PERMIT

SEWAGE DISPOSAL SYSTEM

MARYLAND STATE DEPARTMENT OF HEALTH

SUBDIVISION ROAD 11416 Maryland Rt. 99 LOT 1

Sketch
8/17/81
S.S.

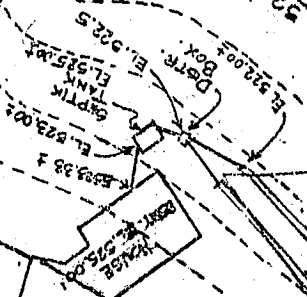
REMARKS 8/21/81 OK to gravel Trench #1 - SK-1

8/25/81 OK TO COVER #1 TRENCH; OK TO COVER FROM HOUSE AND

SEPTIC TANK; OK TO COVER DISTRIBUTION BOX; NEED TO SEE

TRENCH ② & ③ GRAVEL DEPTH AND PAPER PARTIAL; P.M. TRENCHES

COMPLETE.
